# CITY OF TROUTDALE CONSTRUCTION DETAILS INTERIM CHANGES

Construction Standards for Public Works Facilities May 1997:

**Interim Change #1**

Drawing #:		File Name:	
RD254-CoT	Α	RD254 COT A.dwg	
Date:		Drawn by:	
5/17/2012		TH	
REVISIONS			
Date	De	scription	Ву
5/17/2012	Inte	erim Change #20 Issued	TH
Public Works Dept.	342 SW	/ 4th St., Troutdale, OR 97060 503-6	74-3300

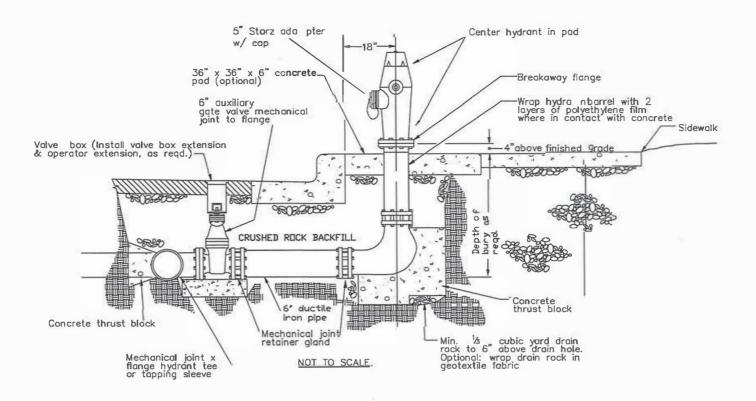
- 1. Replace Standard Drawing IV-2, "Fire Hydrant Assembly (Behind Sidewalk), with the attached drawing RD 254-CoTA, "Hydrant Assembly (Behind Sidewalk)" [Attached]
- 2. Replace Standard Drawing IV-3, "Fire Hydrant Assembly (Behind Curb), with the attached drawing RD 254-CoTA, "Hydrant Assembly (In Landscaping Strip)" [Attached]

- 1. When placed in landscaping strip, see detail RD 254-COT B.
- 2. When pipe is longer than 18' retainer glands not required.
- When pipe is shorter than 18', no joints allowed. Use mechanical joint retainer glands.
   Two ¾" galvanized tie rods may be used in lieu of thrust blocks for installations less than 18' long.
   Coat tie rods with two coals of coal far ecoxy.

- 6. Hydrants shall be placed to provide a minimum of 5' clearance from driveways, poles, and other obstructions.
- 7. Hydrant pumper port shall face direction of access.

- 8. Set hydrant plumb in all directions.
- 9. Public hydrants shall be painted safety yellow. Private hydrants safety red.
- 10. 5" Storz adapter (NST) with pressure cap shall be installed on the 4 1/2" port.

- 11. Storz adapter and cap shall be high-strength aluminum alloy. Cap shall be attached to the hydrant barrel or adapter with tamper-proof cable.
- 12. Storz adapter shall have Teflon coated seat and threads with rubber gashet and set screws.

SEPARATED SIDEWALK DRIVEWAYS OR ALLEYS (OPTIONS H, I & J) LOCAL JURISDICTIONS

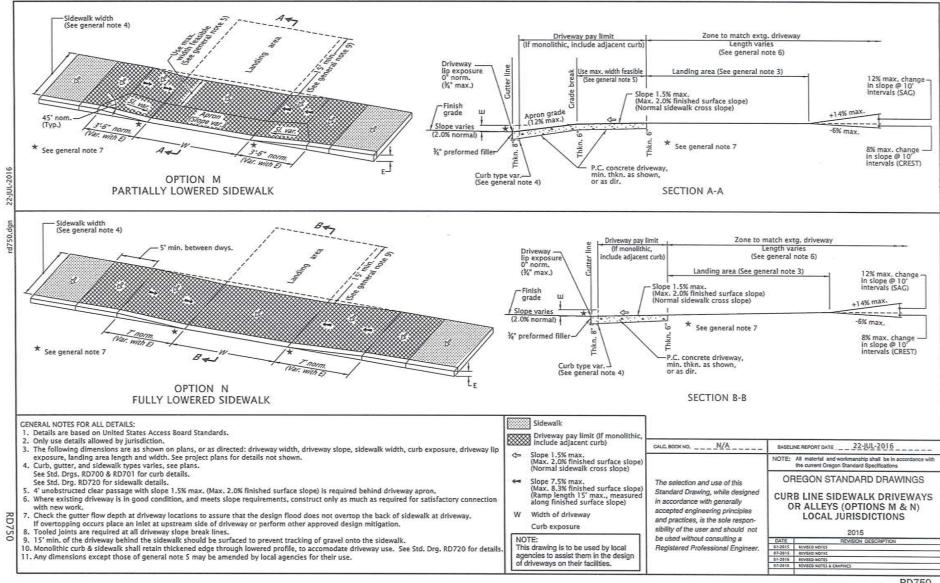
- 1. Replace ODOT Drawing RD 740, "Separated Sidewalk Driveways or Alleys (Options H, I, & J) Local Jurisdictions with the attached drawing RD 740 (bearing the same title).
- 2. Replace ODOT Drawing RD 745 and RD 750, "Curb Line Sidewalk Driveways or Alleys (Options K & L) Local Jurisdictions and "Curb Line Sidewalk Driveways or Alleys (Options M & N) Local Jurisdictions with the attached drawings RD 745 and RD 750 (bearing the same title).
- 3. The following driveway width standards shall apply to all driveway access points onto all City of Troutdale controlled rights-of-way:

II-26

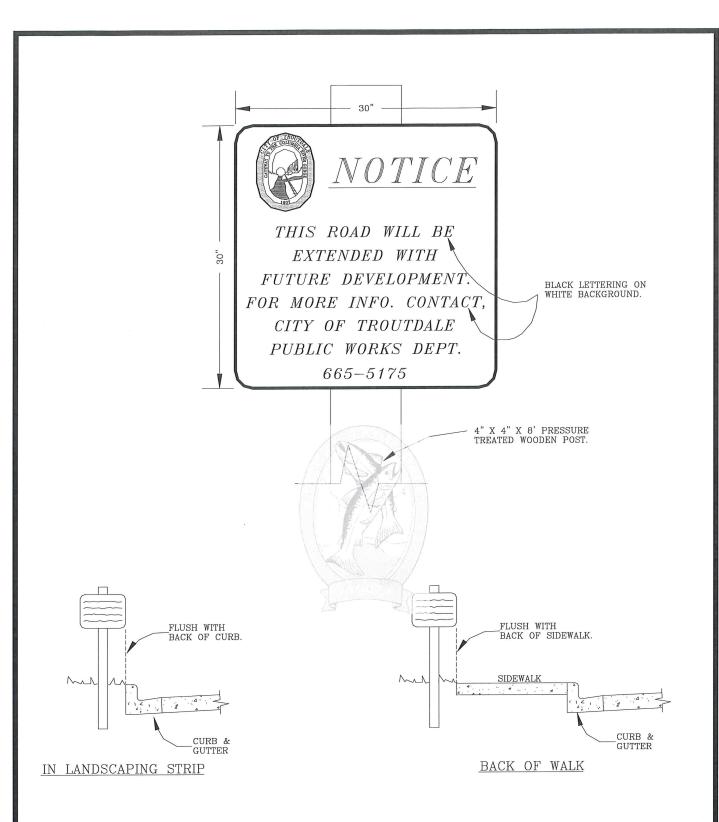
Part II (Streets), Drawing No. II-26 (Gravel Construction Entrance) is amended as follows:

Delete: "Clean Pit Run or 2" minus gravel (or larger if required)"

Add: "3" minus crushed rock"
